PWROG-15060-P, “Pump Suction Gas Accumulation Operability Criteria Guidance ” Draft Safety Evaluation Review Meeting

August 30, 2018

DSE Figure 17

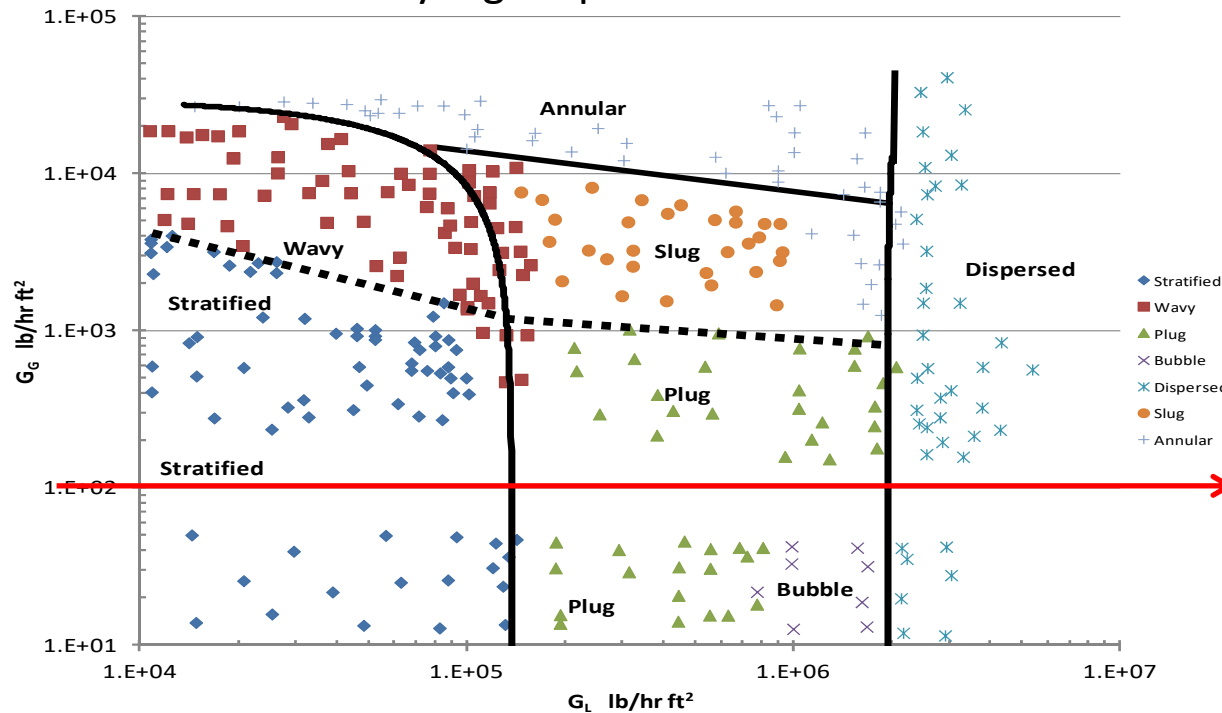
- TR Eq. 6-6 is only intended for use when $N_{\text{FR}} > 1.0$.
 - The TR assumed linear behavior could be assumed out to $N_{\text{FR}} = 2.25$ and that $\beta = 0.188$ for $N_{\text{FR}} > 2.25$. **The effect of not choosing a linear fit is shown in Figure 17, where the dot line provides a third order fit to all of the points and the solid line is the straight line provided by TR Eq. 6-6 that excludes the points for $N_{\text{FR}} = 1$ and 1.9** (DSE Page 46; Lines 28-31)

- The 3rd order fit is not consistent with the flow regime map (slide 16) or test results (slide 17)
